FILETRON PTY LTD

Re: Hume Coal Project SSD 15_7172: Southern Highlands NSW – Objection to Project Approval by Mr Ben Cottle on behalf of Filetron Pty Ltd

Groundwater bore 'make good' consultation correspondence from Hume Coal dated 23.5.17, includes 'Groundwater Bore Overviews & proposed 'make good' bore diagram.

Make good strategy - increased pumping costs only
 Hume Coal Project
 Proposed 'make good' provisions
 Figure 4.1

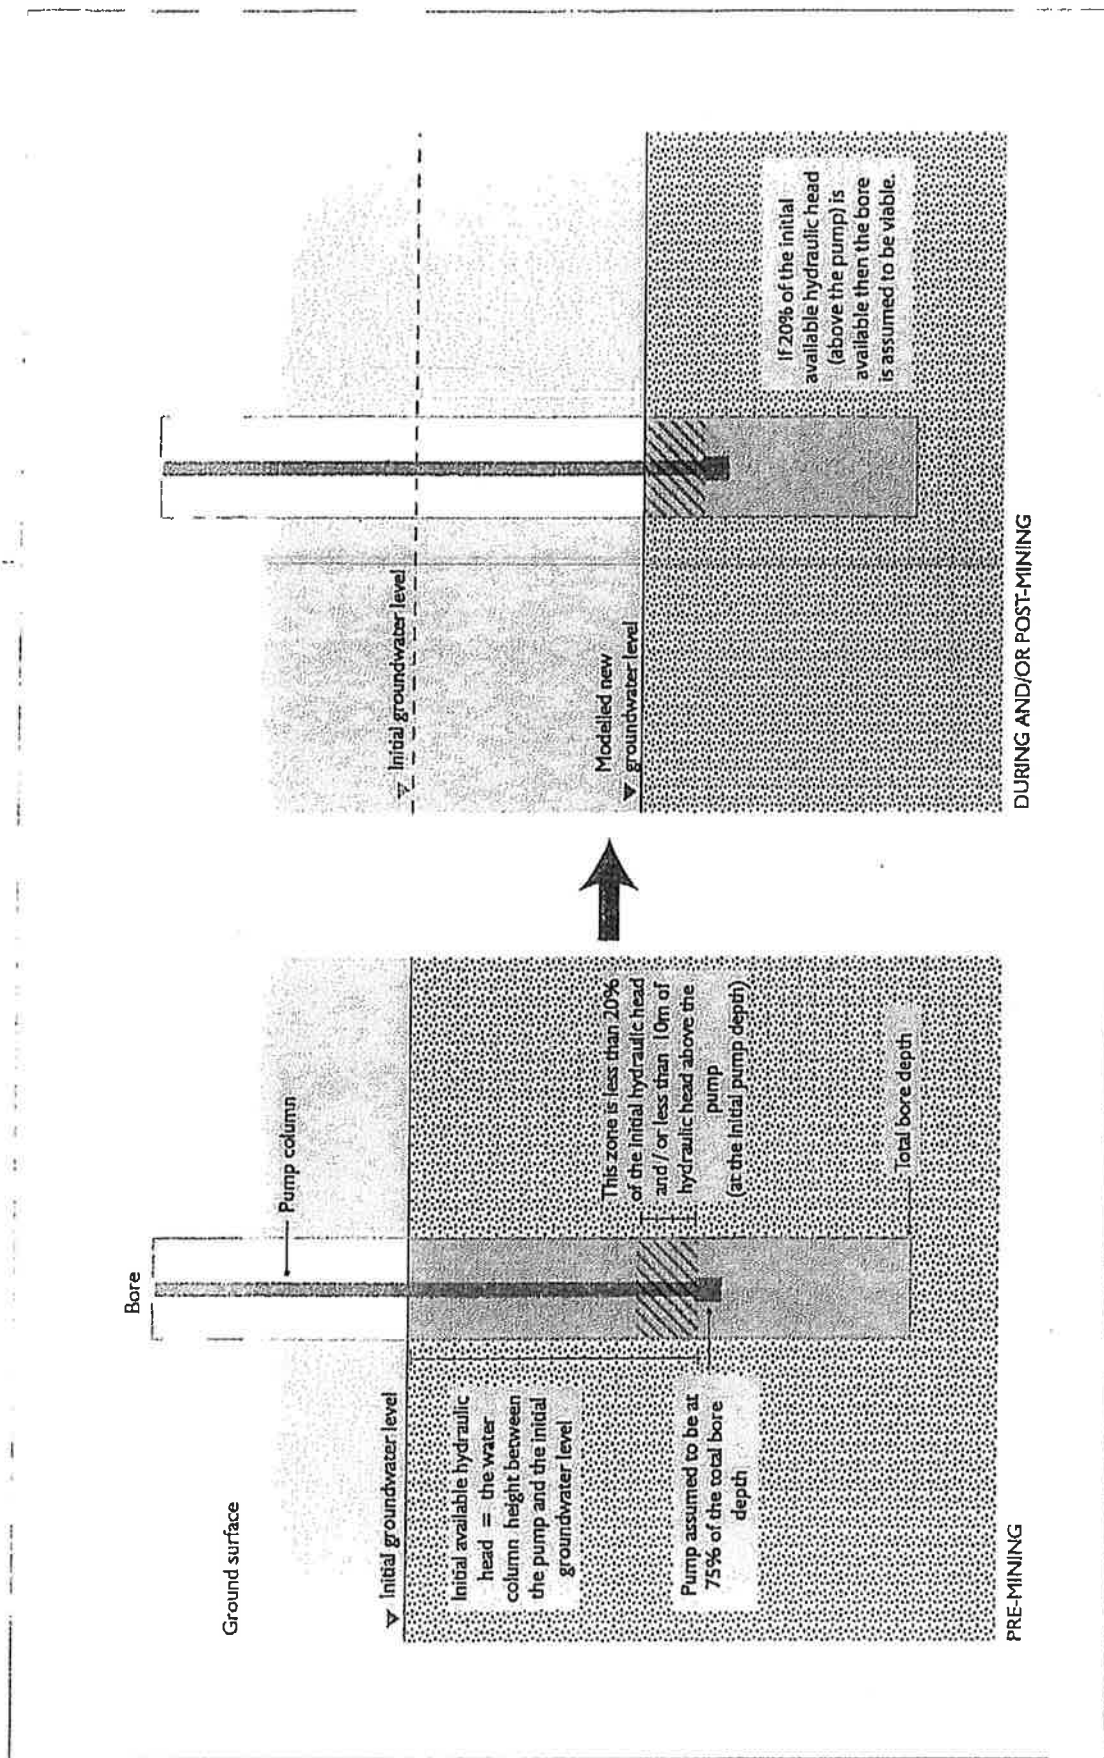
Hume Coal have provided a schematic drawing of the 'Make good strategy – increased pumping costs only', as attached. The advice provided to us in their correspondence is that the *only* costs will be increased pumping costs. That is erroneous for the following reasons:

1. If the pumping head of a bore is increased, costs are associated with the added cost of running the pump for a longer period of time to obtain the same quantity of water for the desired purpose;

2. If the pumping head is increased significantly, the pump may not deliver the necessary volume of water to satisfy the needs, and a complete new pump with a different pump performance curve will need to be installed;

3. When water levels are reduced, there a number of effects - the motor can burn-out if run dry, aeration can occur, and water quality can deteriorate as cascading water dewateres the aquifers;

4. Our bores have all been scientifically equipped, based on detailed drawdown and recovery data analysis, where the impacts of dewatering have been minimized. We are now faced with a complete change in those parameters;

5. It is not just a simple case of lowering the pump without a complete reinstall and aquifer drawdown test under different conditions of reduced head;

6. *Hume* determine that if 20% of the initial hydraulic head is available, then the bore is assumed to be viable. This nonsense, as the viability of a bore depends on the inter-relationship of the water level and positions of the aquifers;
